### System Sanitary Survey Report

SUBJECT: Richmond City  
Waterworks: Richmond, City Of  
PWSID: VA4760100

Survey Date: February 23, 2026

*Figure 1. Electrical substation*

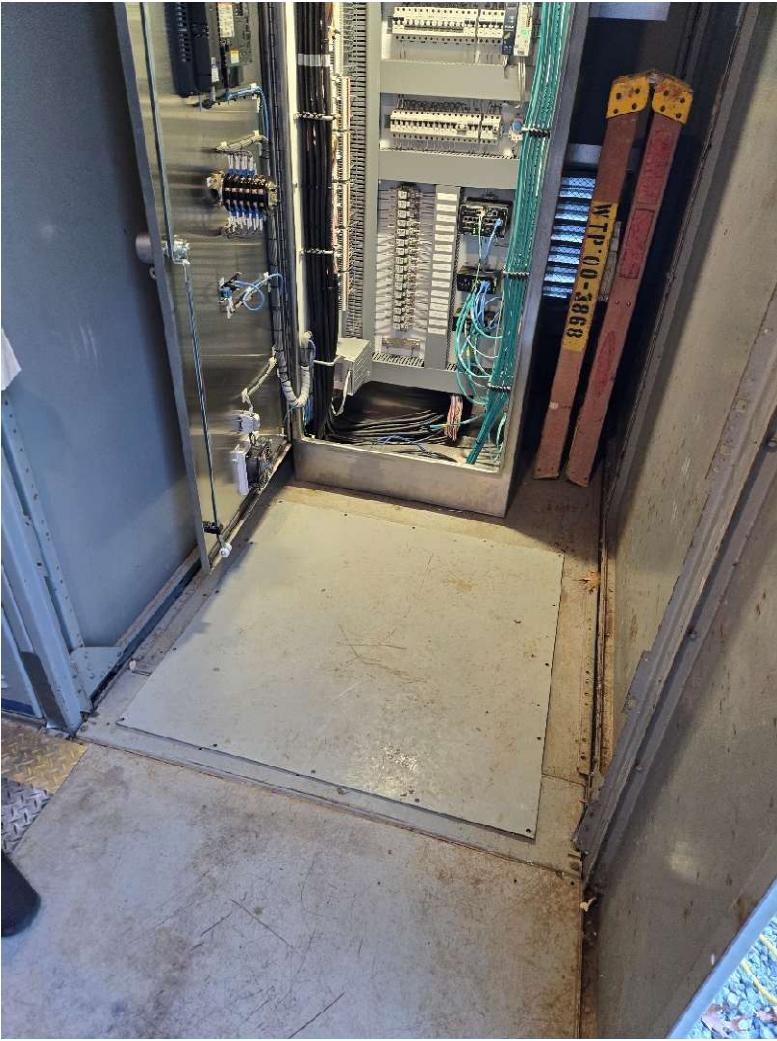
- Electrical substation project was in progress to replace/rehab the substation (Figure 1)
- Automatic transfer switch was installed to allow automatic activation of the generators should both substation feeds go down. The transfer switch was tested and worked successfully. (Figure 2)

Figure 9. Raw pump motor screen (2025 left), Screen intact, all raw water pumps checked (2026 two photos on right)

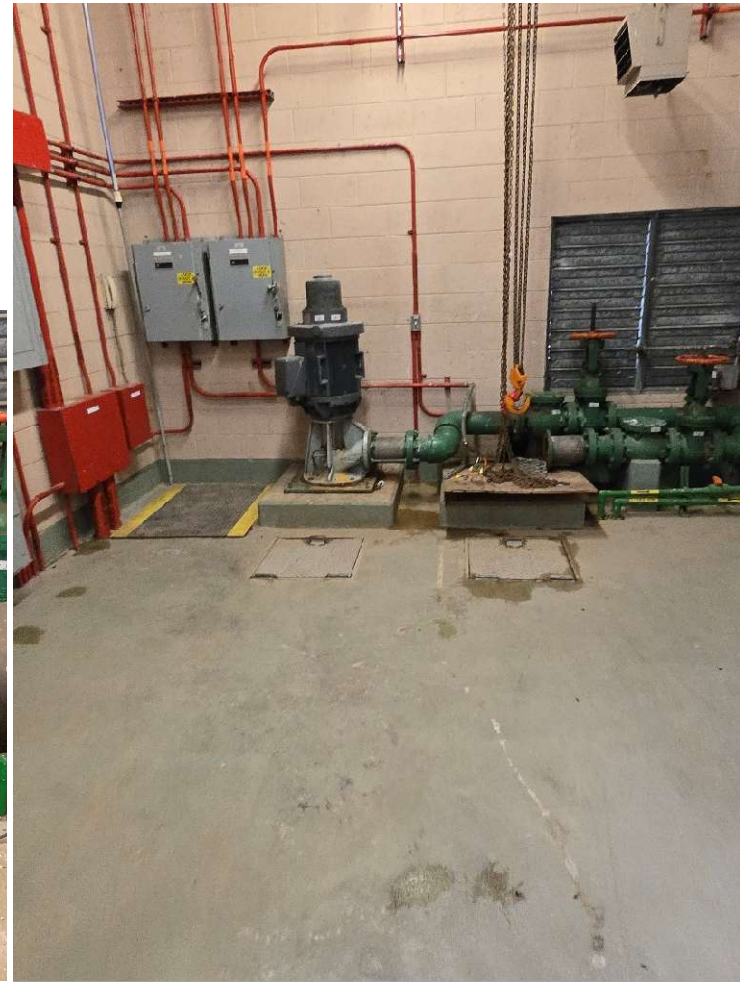
- Raw water pump shaft safety guards all in place and intact (Figure 9)
- No bird droppings or trash observed in raw water pump buildings, all buildings clean and orderly (Figure 10)
- All pumps operable
- Permanganate being fed year round downstream of raw water pumps (Figure 11)

Figure 15. Obsolete equipment abandoned in place (2025), Wiring removed as much as possible (2026)

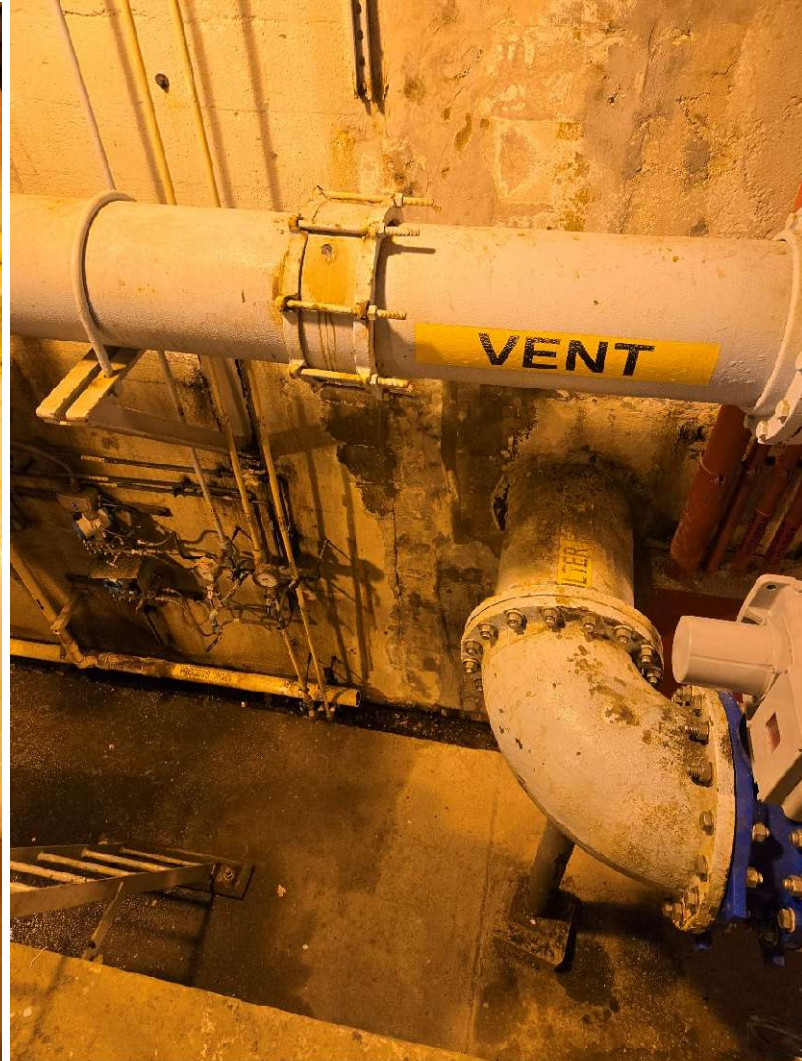
- System has resumed filter drop tests, backwash expansion tests. Plans to incorporate routine filter rise tests in 2026.
- Some of the obsolete electrical wires and associated equipment that were previously observed in the filter gallery have been removed as much as feasible and cleaned up (Figure 15)

Figure 17. Leak and biological growth (2025); No leak observed (2026)

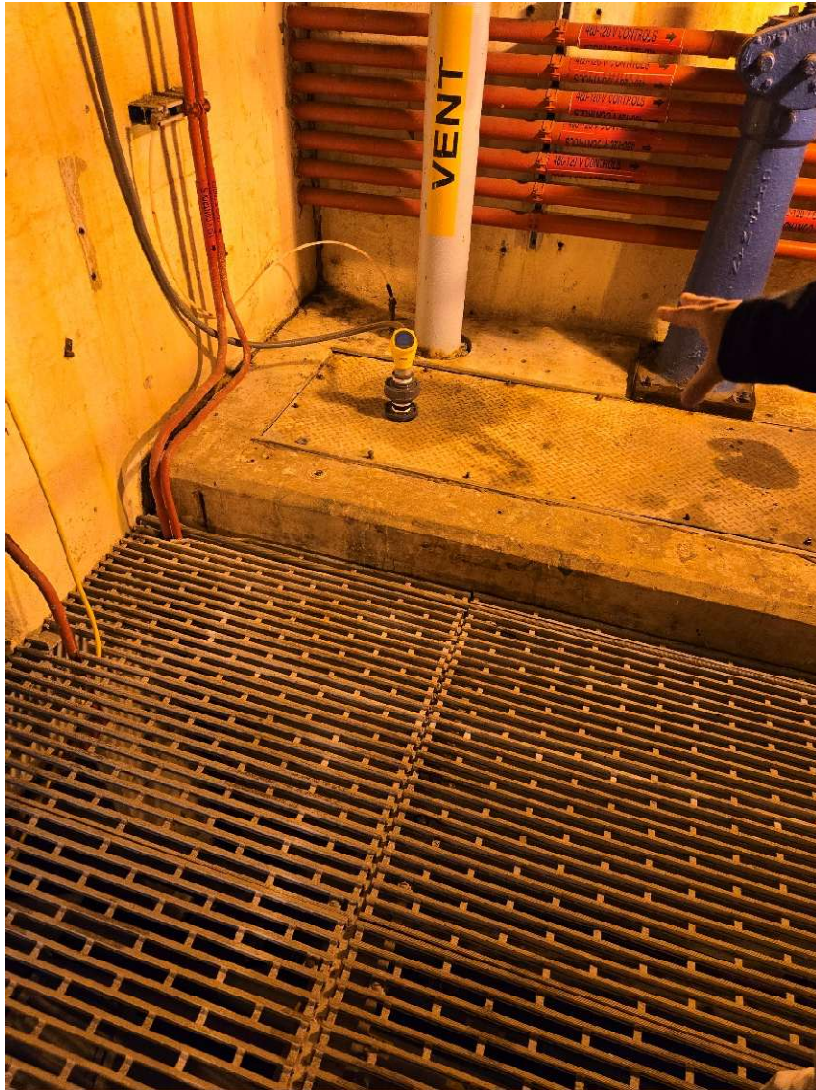
- No active leaks or biological growth observed (Figure 16, Figure 17)
- Backwash waste area appeared to have less standing water (Figure 19)

Figure 20. Water beneath grates visible, no solid base on walkway (2025); Grates covered (2026)

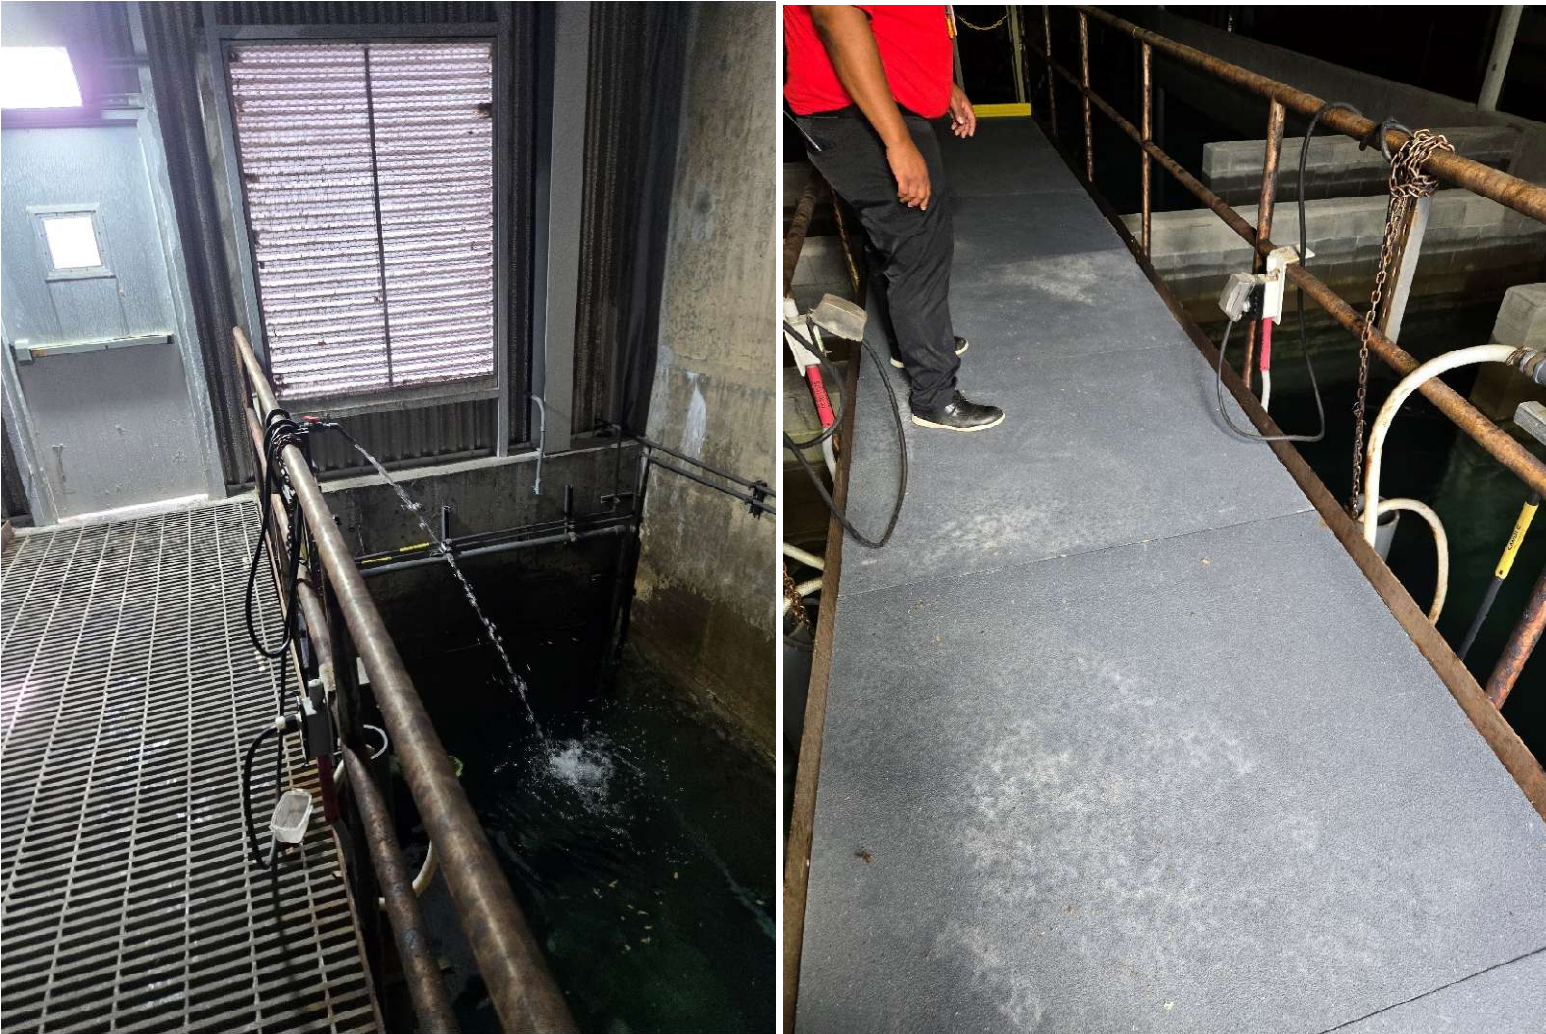
- All walkways into finish water basins have curbing, solid walkways to prevent dirt from falling into water (Figure 20)
- Walkways appeared clean with no debris observed (Figure 20)
- No scum observed at end of basins (Figure 21)
- System instituted routine cleaning of basins
- Previously observed obsolete PVC lines have been removed (Figure 22)
- Finish water basin lighting appears to have improved, brighter inside basins

Figure 23. Obsolete turbidimeters (2025), New turbidimeters (2026)

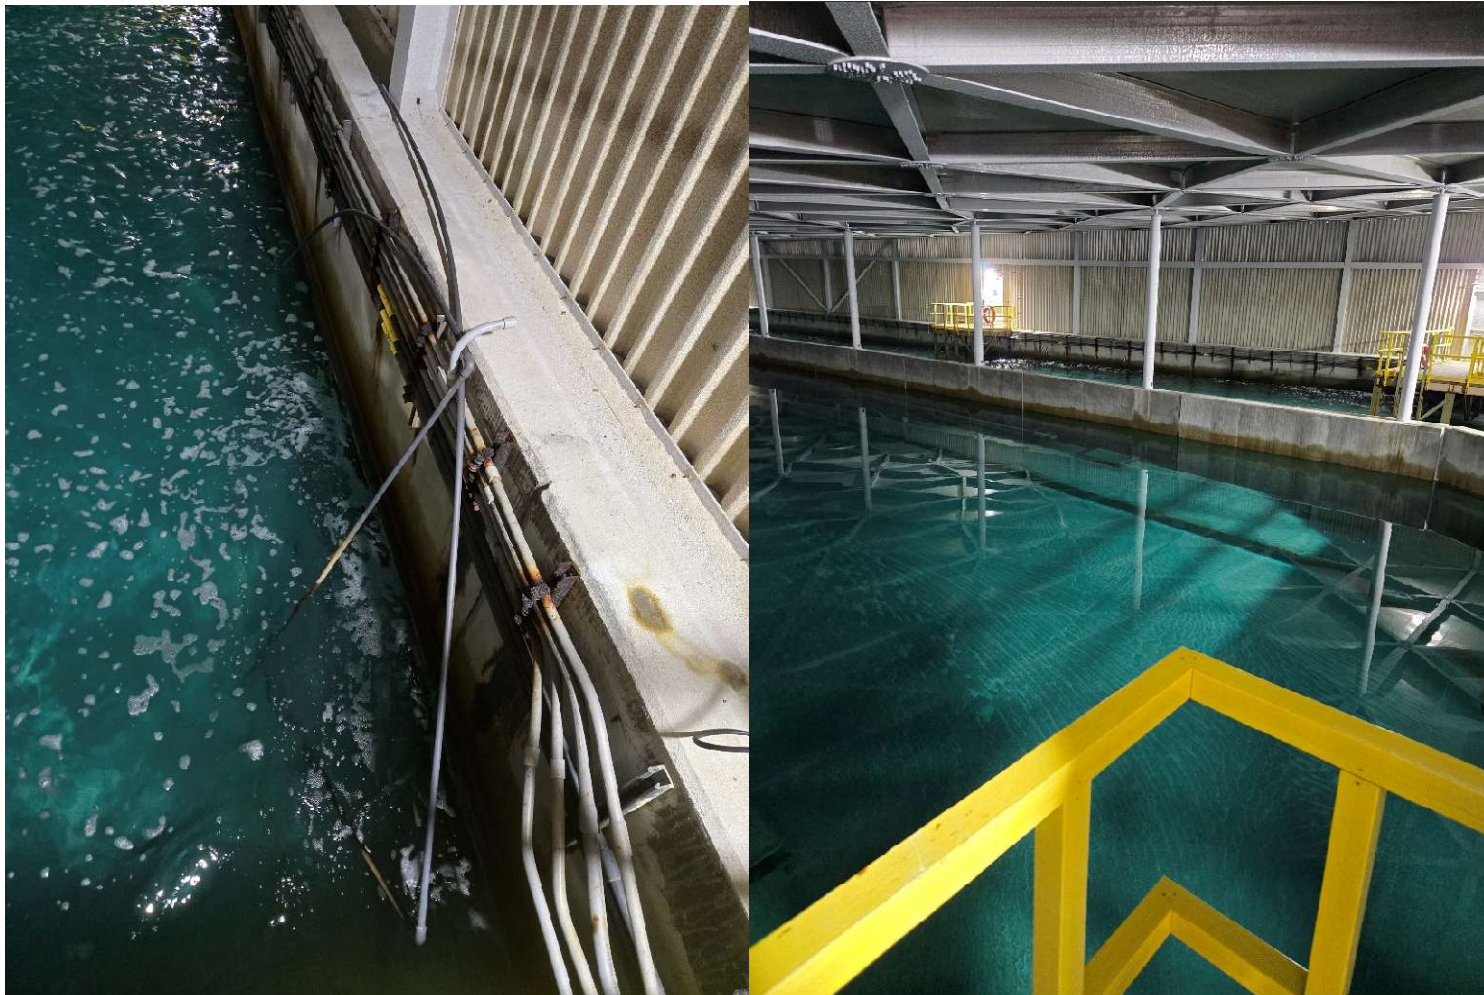
- Filter turbidimeters have been replaced with new equipment that have approved analytical methods (Figure 23)
- After around June 2025, there were no instances of individual filter turbidity readings of 2.00 NTU or greater on the monthly operation reports. Appeared to be a SCADA issue. System indicated they investigated signal span and have corrected previously observed issue

<b>VDH-11</b>	Filter Instrumentation	Hach turbidimeters (FilterTrak 660sc and 1720E) appear to be obsolete by the company, making it harder	Turbidimeters replaced with newer units, units	Resolved	Figure 23

*Figure 27. Sanitary waste storage tank with concrete containment curbing*

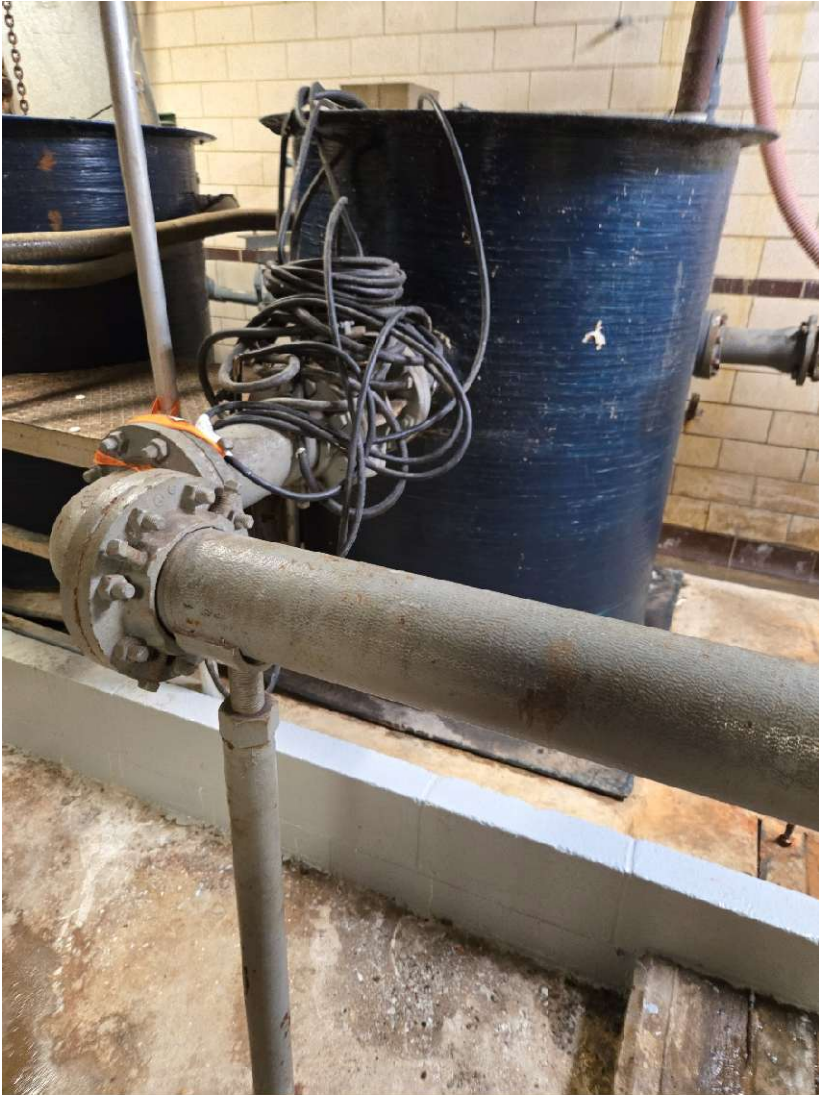
- Current sanitary holding tank and pump system provided with containment and planned to be replaced to pump sanitary waste directly without holding tank (Figure 27)
- System reports recycle flows on MORs using flows at waste lagoon, typically below 10% of total treated water flow. Recycle flow discharges at head of presedimentation basin, a lot of detention time prior to entering WTP raw water pumps. Direct measurement of recycle flow not done at discharge site due to water discharging through a sluice that connects waste lagoon and presedimentation basin
- Waste lagoon dredging project to start in March
- Waste pump No. 2 check valve appeared to need repair, pump observed spinning backwards momentarily. **Recommend investigation and repair of check valve at Waste Pump No. 2**

*Figure 30. Corrosion at several pumps (2025), Pumps painted and no visible corrosion (2026)*

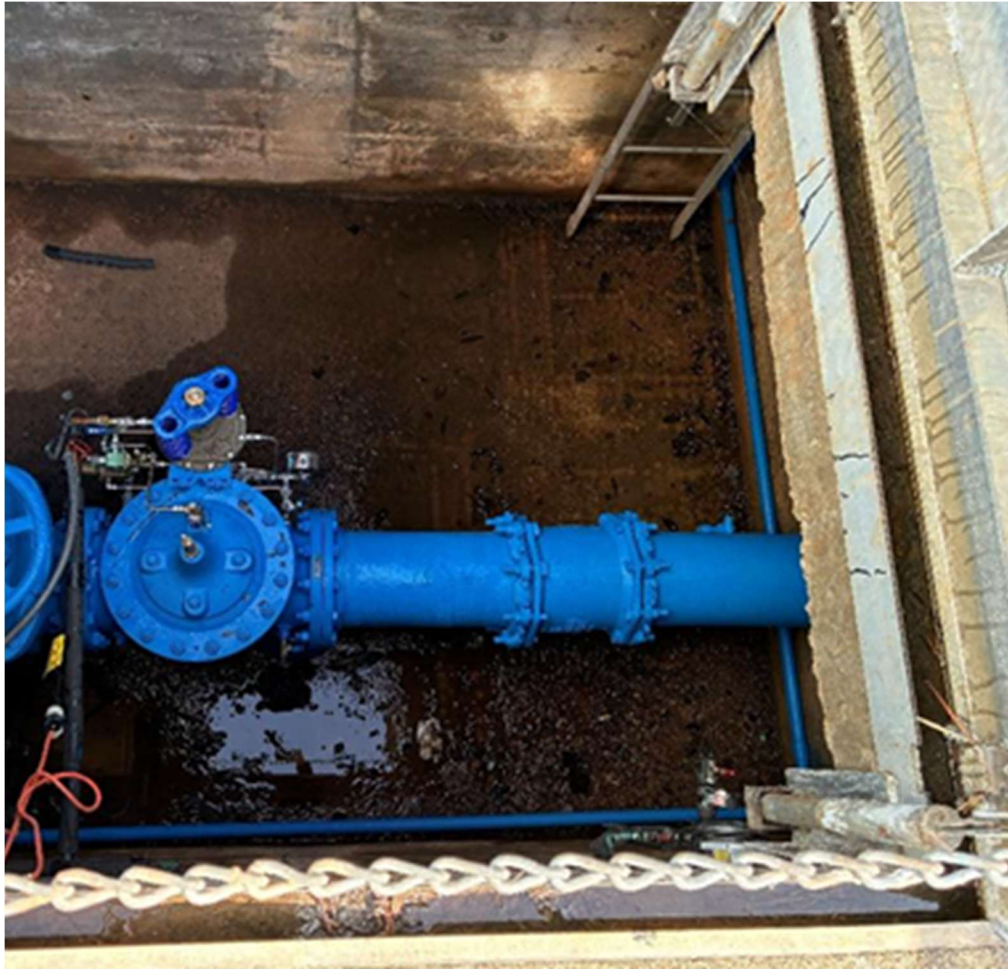
- Distribution system pumps appeared to be painted and no major signs of corrosion (Figure 30)
- Housekeep in distribution system appears to be improved, no signs of trash

<b>VDH-09</b>	Distribution System Tanks	Several tanks equipped with overflows that were piped to stormwater drains and sanitary sewer with no knowledge of backflow prevention provided. COR should investigate connection and determine degree of hazard and provide appropriate protection.	System investigated and provided adequate protection as needed	Resolved	None
<b>VDH-10</b>	Multiple Locations	There are various pumps, valves, piping, and other equipment that appear to have severe corrosion that may result in failure of the critical infrastructure. COR should conduct a condition assessment of all their assets in both the WTP and distribution system and identify what assets need repair, rehabilitation, or replacement.	Pumps, valves, and other equipment appeared to be repainted with no corrosion observed where painted. Waste pumps appeared to have some corrosion but are scheduled to be replaced with new equipment	Resolved	Figure 30
